STAFF REPORT 7-10-2019 MEETING
APPLICATION NUMBER 19-6314
ADDRESS: 1778 SEYBURN
HISTORIC DISTRICT: WEST VILLAGE
APPLICANT: GEORGE DANAYAN / GERALD GRUBEY
DATE OF STAFF VISIT: 7-3-2019

ADDITIONS, ALTERATIONS, & REPAIRS TO BACK OF 1778 SEYBURN STREET, DETRIOT, MI

Exhibit 4: Photos of Original condition and current Rear Porch

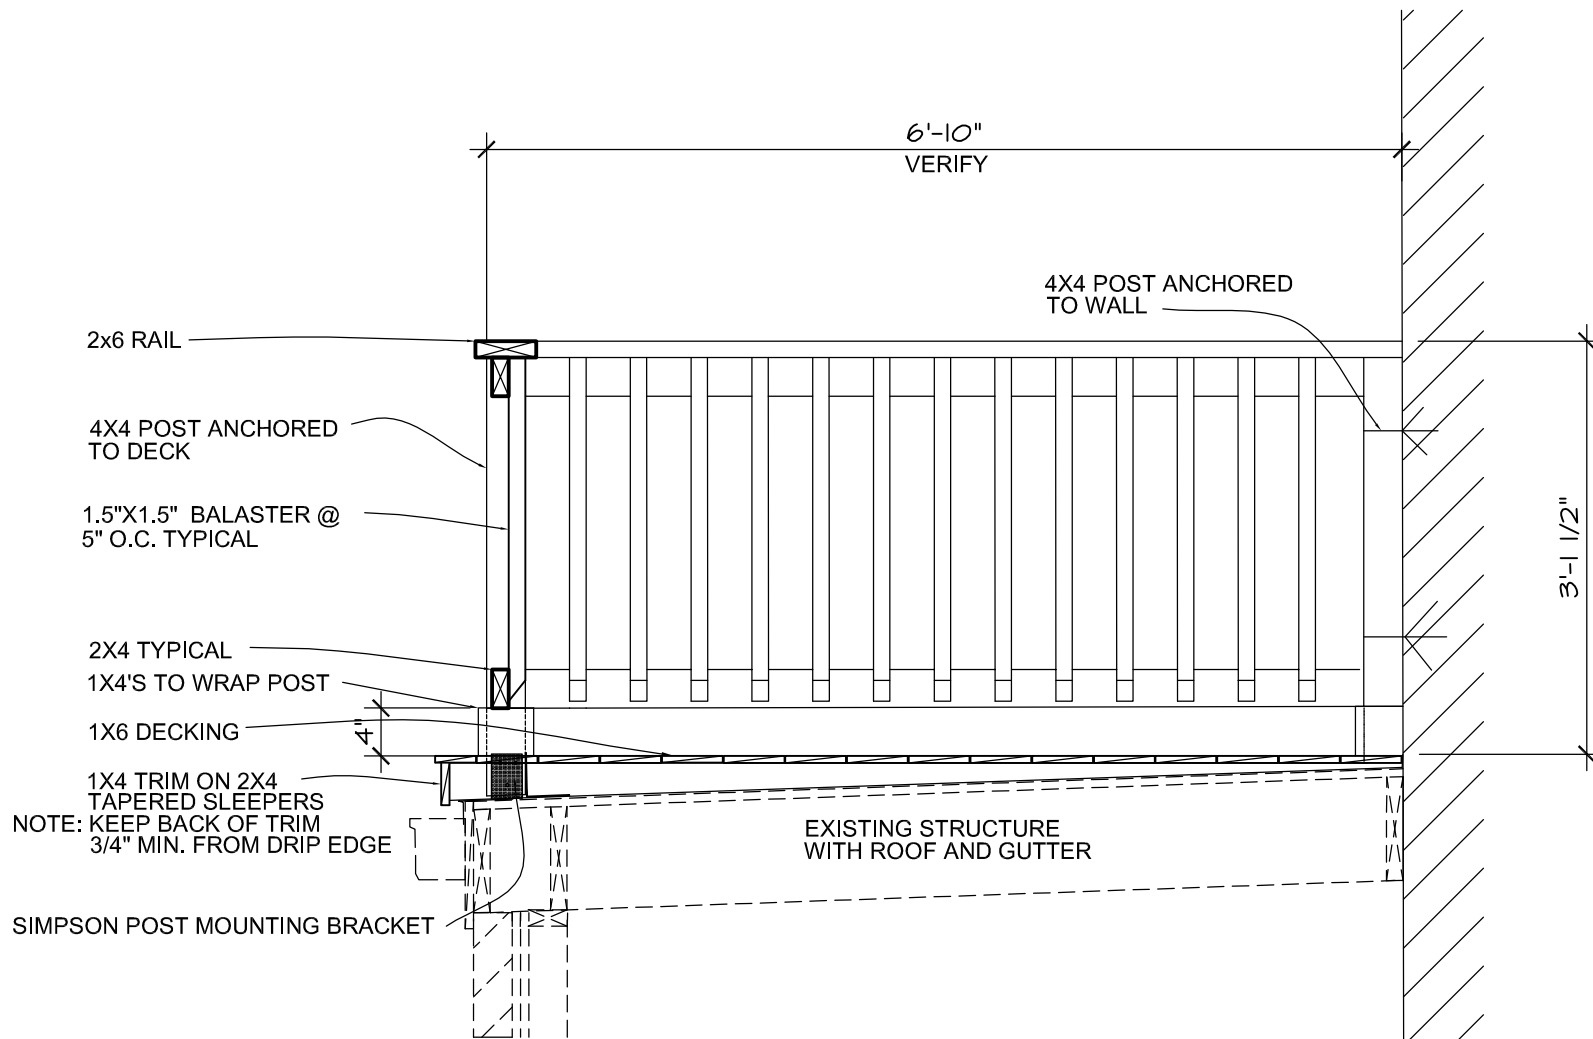
Current: closed-in upper deck porch has been removed

Before: Rear porch, structurally unsound.

Plan: Add railings to upper deck to match lower porch railings

Exhibit 5: Photos showing Deck Railing Details Door Relocation

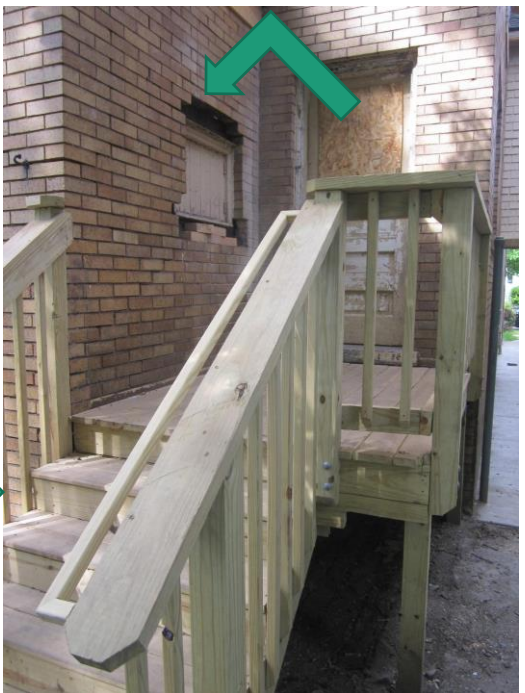
Current: Rear entrance railing details

Plan: move door to left wall where current opening is located

Finally, staff does not offer an opinion if the in-filling of the rear door opening with brick and the creation of a new doorway onto the rear porch is appropriate under Standards 6 or 9.

Exhibit 6: Existing Garage Photos

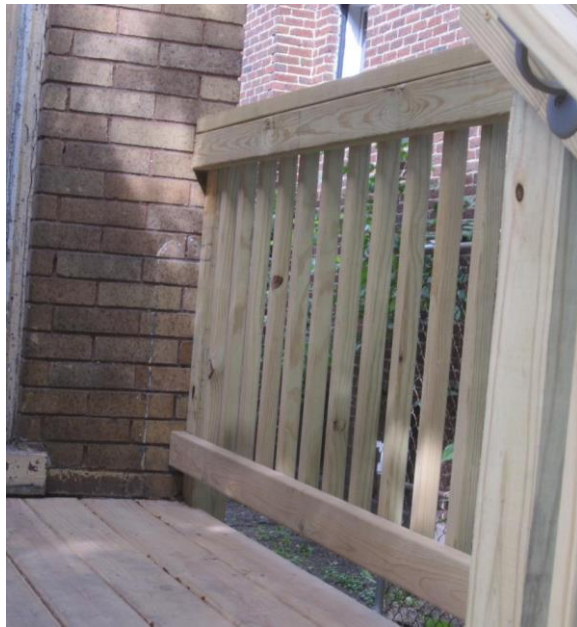
Current: Two car garage built
on slab

Plan: Replace siding with
appropriate color (per
samples) with similar details
to blue neighboring garage
circled above.

It should also be noted that vinyl siding is not typically a historically appropriate material for a home in a historic district and there has been some recent discussion among the commission concerning the use of vinyl siding in historic districts. Therefore, staff recommends that the garage be clad in wood siding in favor of vinyl which would be appropriate under Secretary of the Interior Standards Number 6. However, **vinyl siding can be found on other garages on Shipherd Street with various results.**
